**COMMENTS & RESPONSES ON THE  
GRPE DRAFT ECE COMPRESSED GASEOUS HYDROGEN (CGH<sub>2</sub>) REGULATION  
Version 10 Dated 06.11.02  
(NON GRPE/ISO HARMONIZATION)  
Results of the GRPE CGH<sub>2</sub> Experts Meeting in Munich 23-24 January 2003**

**GRPE - 006**

2003-01-24

**Table 1: GENERAL COMMENTS**

Figure X: Flex-impulse testing fixture

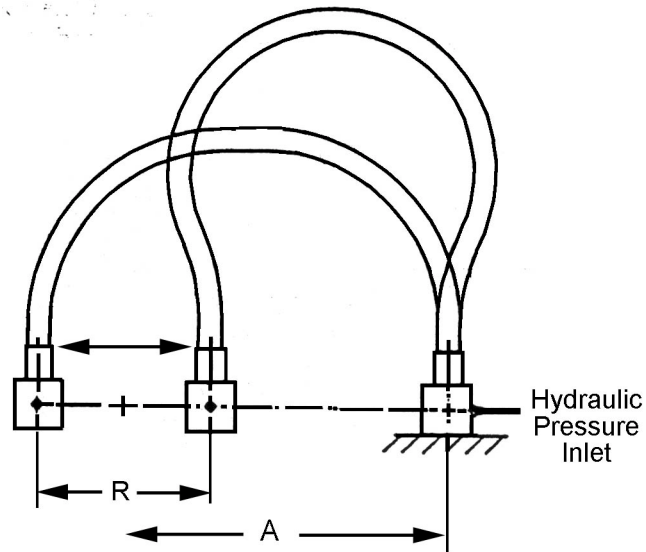
**Replace B5.2.3 with a combined flex-impulse test adapted from SAE J1405.**

The *Flexible Fuel Line* shall be bent in the manner depicted in Figure X and attached to a fixture in that position by the *Fittings* with which it is to be approved. One end of the *Flexible Fuel Line* shall be attached to a reciprocating manifold and the other end shall be attached to a stationary manifold connected to a hydraulic supply. The *Flexible Fuel Line* shall be pressurised quickly by means of a quick opening solenoid valve, such that one cycle consists of holding the pressure at 1.25 times the *Working Pressure* for  $10 \pm 1$  seconds (except for *Flexible Fuel Lines* with a required material temperature of  $120^{\circ}\text{C}$  where the hold pressure shall be 1.37 times *Working Pressure*) and then reducing it to less than 0.1 times the *Working Pressure* for  $5 \pm 0.5$  seconds. The total number of test cycles shall be equal to 2.0 times the number of *Filling Cycles* or *Duty Cycles* as appropriate to the use of the *Flexible Fuel Line* in accordance with Paragraph 2.4.6 or 2.4.7 of this Regulation as appropriate. 50% of the test cycles shall be performed at the minimum and the remaining 50% at the maximum material temperature in accordance with Paragraph 2.4.5.1 of this Regulation.

Superimposed on the hydraulic pressure cycles is a flexing cycle. The flexing rate shall be  $36 \pm 2\%$  of the hydraulic pressure cycling rate. This assures that the *Flexible Fuel Line* is in a different configuration on each succeeding pressure cycle impulse. The test fixture is shown in Figure X with the distance A calculated as:

The *Flexible Fuel Line* shall not show any visible signs of damage.
